Project Name: BCH Realty, LLC - Del Arte

**Subject: BCH Realty, LLC Site Plan
Prepreliminary/Preliminary Site Plan
and SEQRA Review
20 Mountainview Avenue, Orangeburg
74.07/1/27; LI & CC zoning districts**

**PB #20-16: BCH Realty, LLC Site Plan
Preliminary Site Plan Approval
Subject to Conditions/ Neg. Dec.**

**Town of Orangetown Planning Board Decision
May 27, 2020 – Virtual Meeting
Page 1 of 11**

EMERGENCY OVERFLOW SPILLWAY DETAIL
N.T.S.

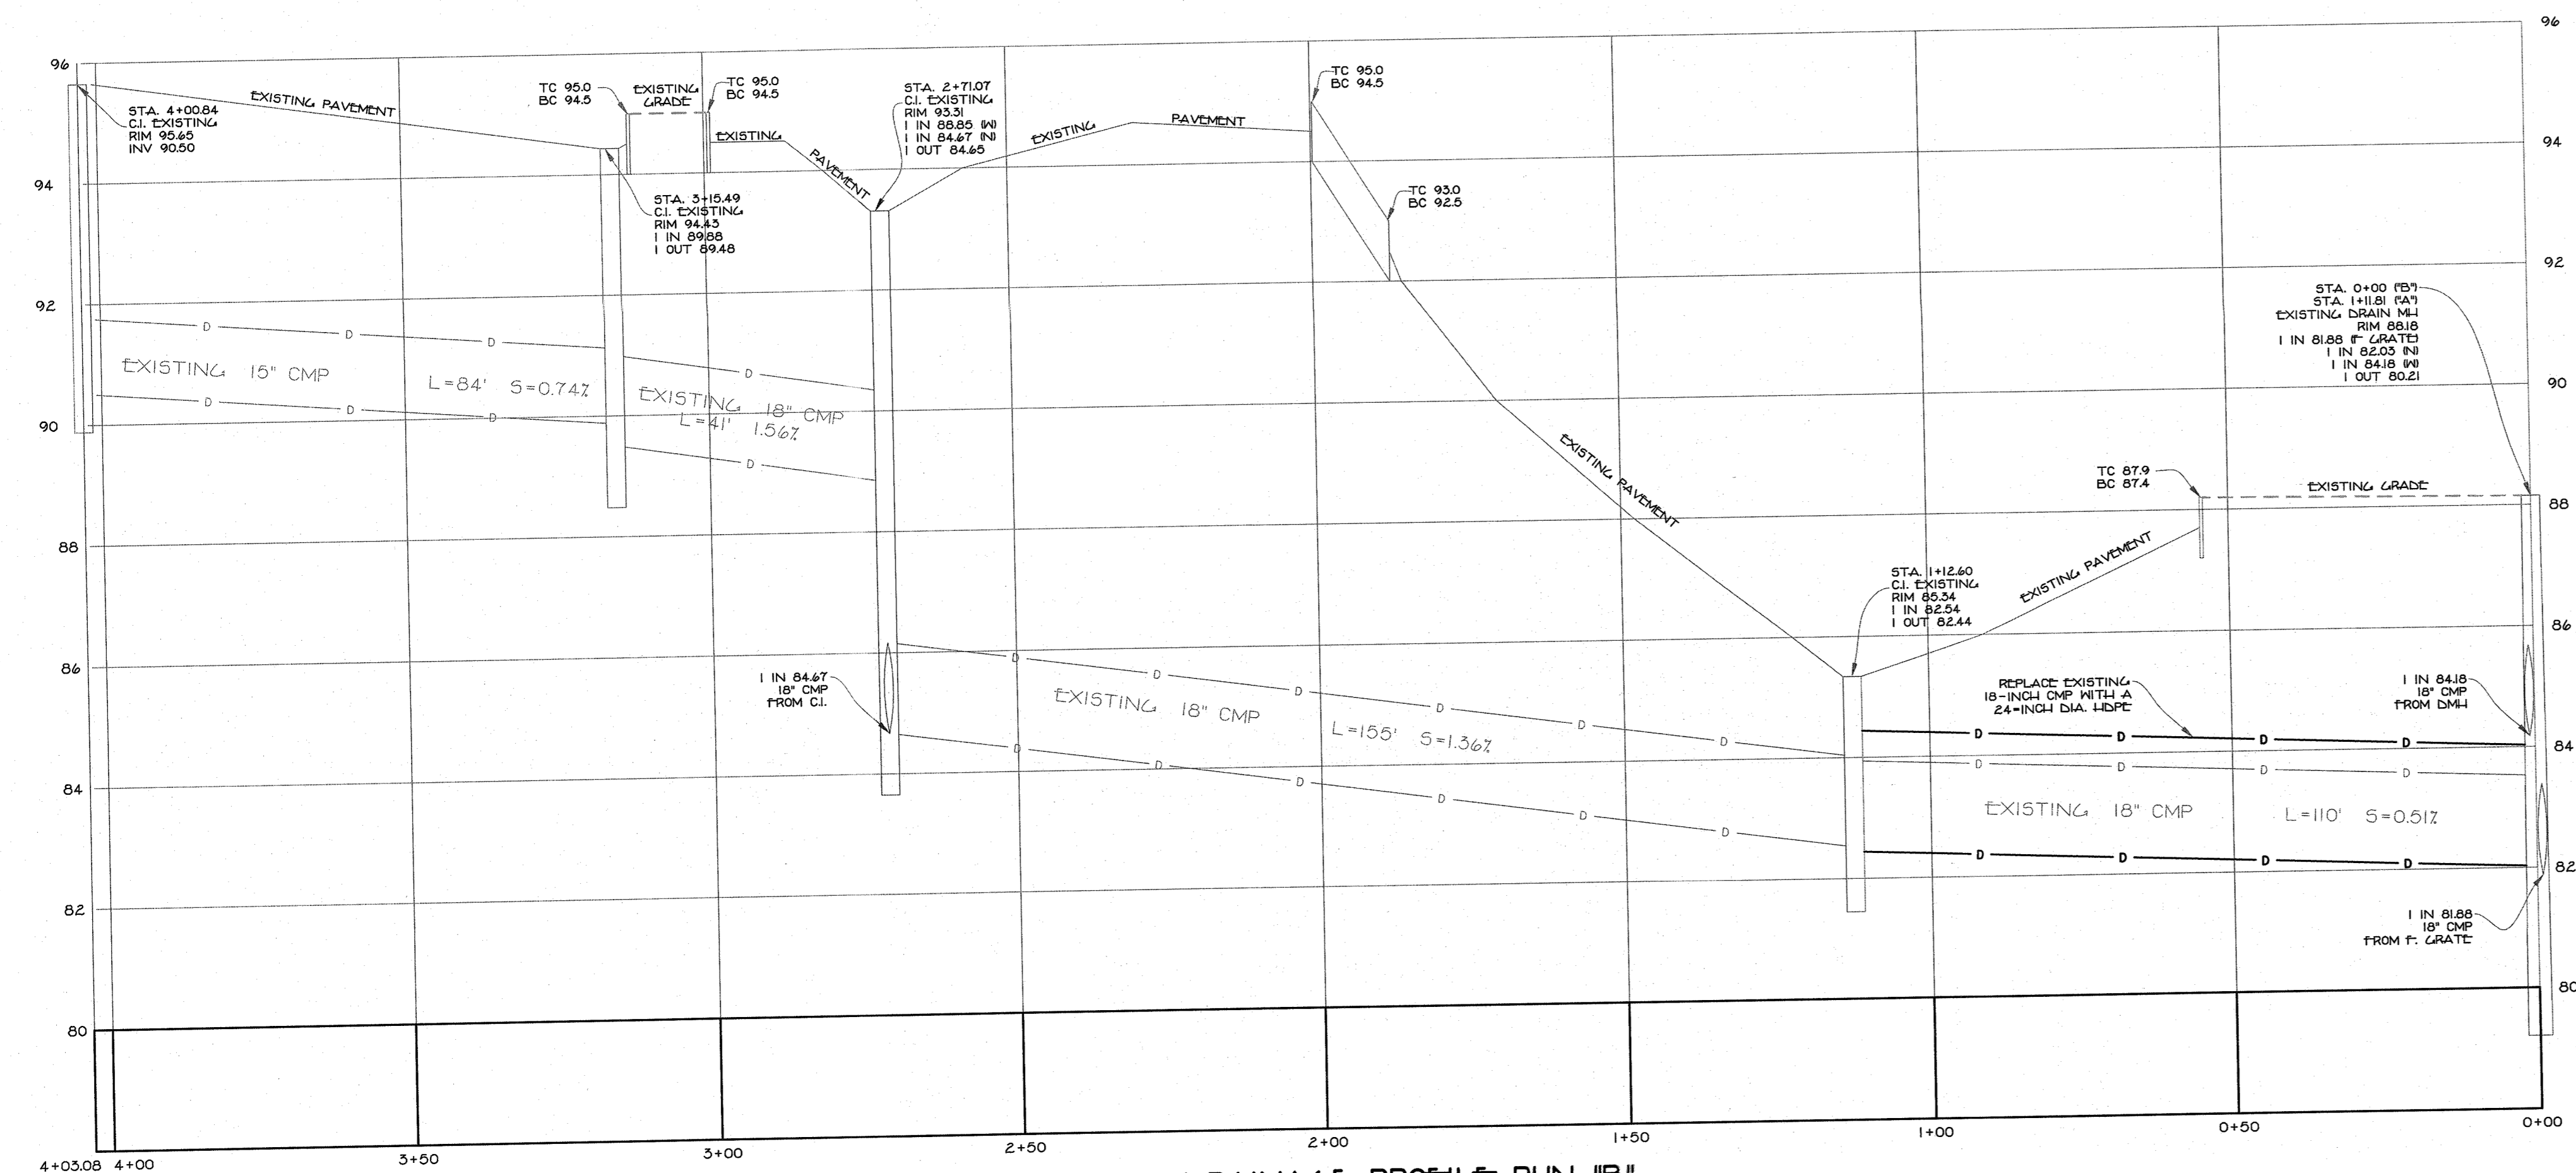
10. An emergency spillway shall be added to the detention basin which is to be expanded in capacity. A detail for same shall be added to the drawings.
11. The proposed improvements shall extend where the current fencing is around the detention basin. This shall not only be labeled as to be removed, but also relocated around the new extents of the basin. This shall be clearly shown on the drawings.

3. Provide a section through the pond with side slopes, outlet structure, and 100-year floodplain.
 4. Provide a detail of the emergency overflow weir.

PARKING AND STRIPING DETAIL
N.T.S.

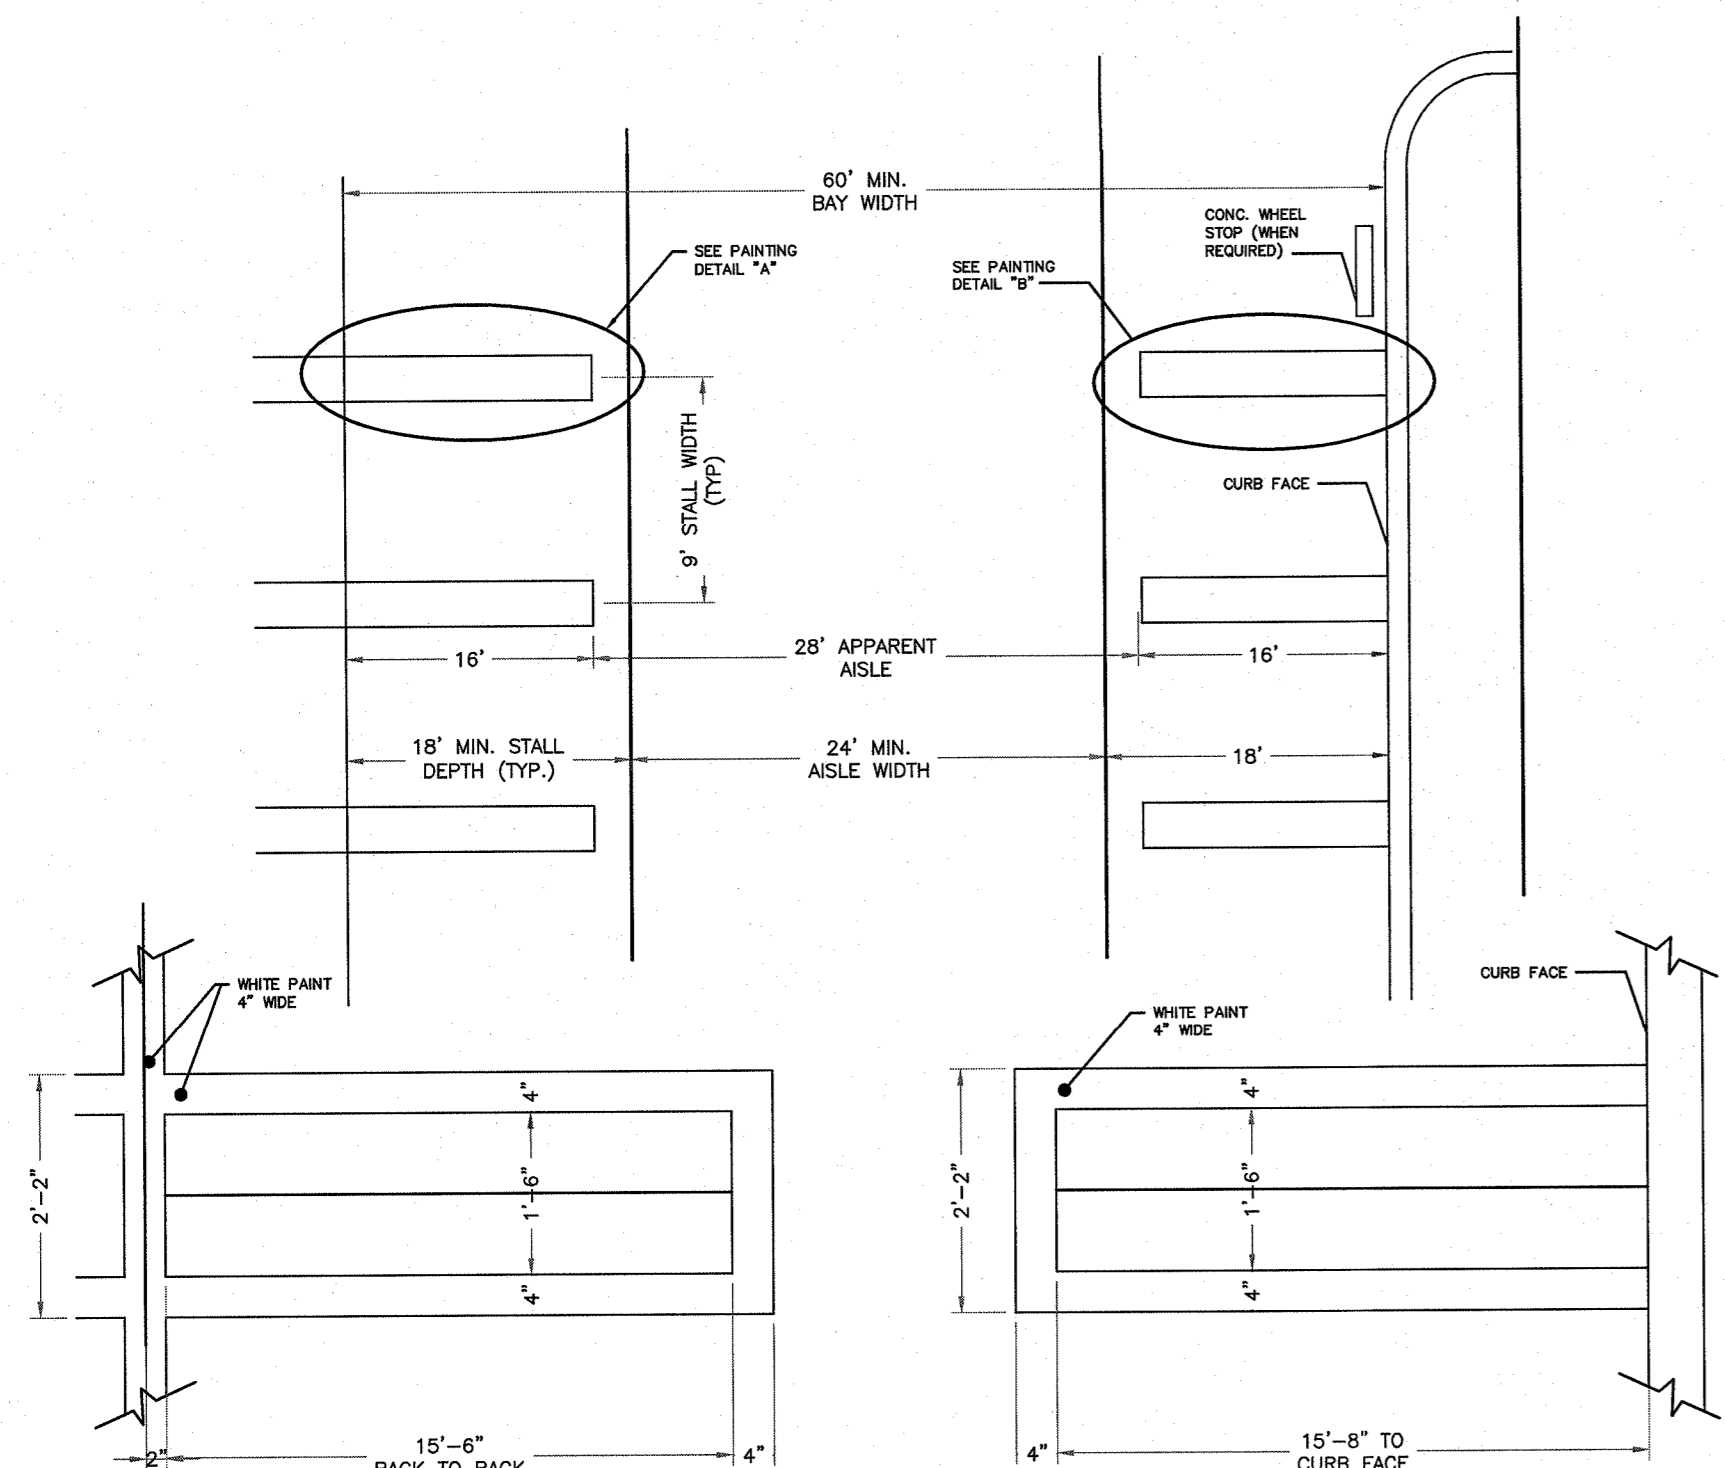
- 3) Per Chapter 43, Article IV, section 6.34, *Size of spaces, a parking space shall be considered a space nine feet wide and 18 long.* The 10 proposed spaces in the rear of the property are indicated at 8' in width. This must be revised to 9'.
- 4) All existing overhead door locations shall be shown. There are currently four (4) loading berth areas, is the intent to eliminate them?
- 5) The basement area must be provided and included in the calculations.
- 6) Plans indicate, "retaining wall as designed by others." Engineering drawings, details and specifications must be provided for the proposed retaining wall, which ranges in height from 2.5 feet to 7.5 feet.
- 7) ACABOR review and approval is required.
- 8) The SEAF appears to be in order.

- 3) Per Chapter 43, Article IV, section 6.34, Size of spaces, a parking space shall be considered a space nine feet wide and 18 long. The 10 proposed spaces in the rear of the property are indicated at 8' in width. This must be revised to 9'.

STONE RETAINING WALL DETAIL
N.T.S.

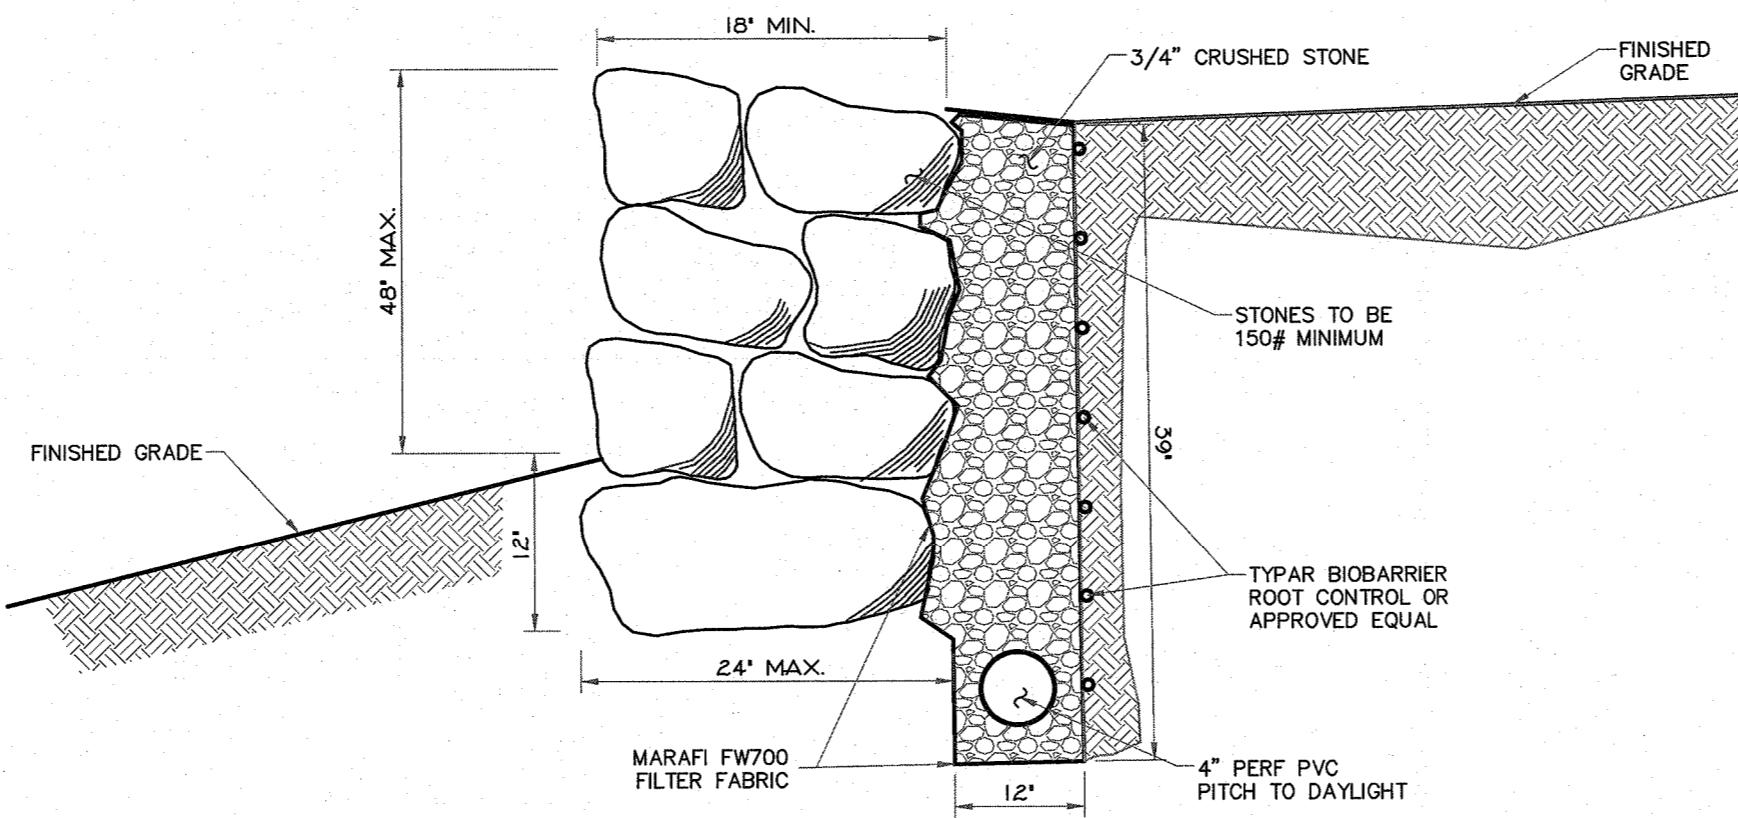
18. The previous supplied drawings had a detail for the proposed stone retaining wall, along Mountainview Avenue at the entrance to the site. This detail was remove. The detail shall be placed back on the drawings.
